Aircraft Design Certification GmbH Reichensteinstr.48 69151 Neckargemünd		Bristell B23 - Exhaust retrofit	Doc-Nr: ADxC-73-SB-044 Issue: A Date: 14.05.2024 Change-no.: ADxC-73-DC-110
Service Bulletin

Bristell B23
SERVICE BULLETIN

<p>Bristell B23 - Exhaust retrofit</p> <p>Optional retrofit of exhaust system with higher diameter tubing (DC-110). , Optional retrofit of exhaust system and silencer with higher diameter tubing (DC-115) with corresponding changes to the DC-110 exhaust system and front fuselage. Subsequent furnishing of AFM and AMM supplements. Version without silencer (DC-110) and with silencer (DC-115) both described in this bulletin.</p> <p>Reduction of Exhaust back pressure</p>

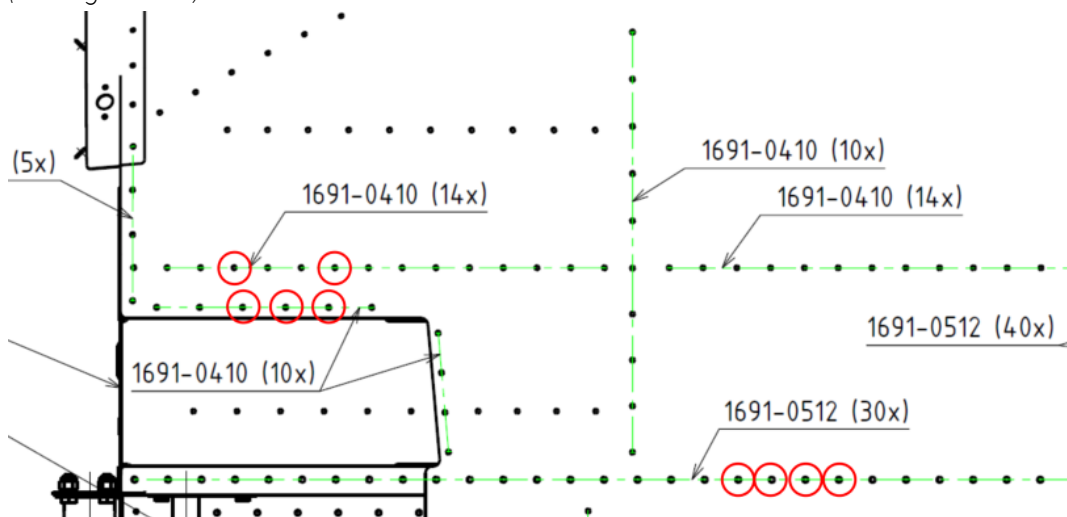
- 1) Remove silencer (if installed). For instructions refer to chapter 78-20 of the DC-012 maintenance manual (ADxC-73-012-AMM, , ref. 1.11).
Remove the complete original type design exhaust system (71B24000N). For instructions refer to chapter 78-00 of the main maintenance manual (ADxC-73-001-AMM, ref. 1.11).
- 2) *Unrivet rivets 19-22 counting from the first rivet on the firewall in the row left of the Nose Landing Gear bay and on the over next row rivets 4-6, as well as the rivets 4 and 7 in the adjacent row (leaving out 5&6):*

- 3) *Install the supplied brackets oriented as depicted on the installation drawing.*
- 4) *Relocate electric connector and drain hoses as defined on drawing 71B240135N.*
- 5) Install the supplied exhaust/silencer assembly 71B241100N (according to drawing 71B241000N and its supplement 71B241100N)
Mount the clamps on the main silencer body (front and rear) to the shock absorber bracket (sandwiching of the shock absorber metal sheet: *clamp – shock absorber – clamp*) by use of the defined washers, bolts and nuts. Just tighten the bolt-connection so that the clamp is still movable in axial and radial direction.

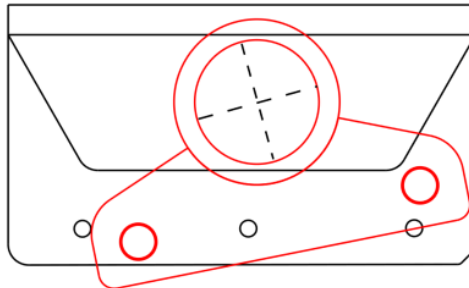
- 6) Connect the main body of the silencer to the flexible hose using the supplied springs.
- 7) Position the silencer main body and clamps, so that the middle point of the bushing of both shock absorber brackets is the most possible in the middle of the fuselage brackets:

Mark the middle point of the bushing on each bracket. Drill an 8mm hole at the marked position into each bracket and smooth the edges.
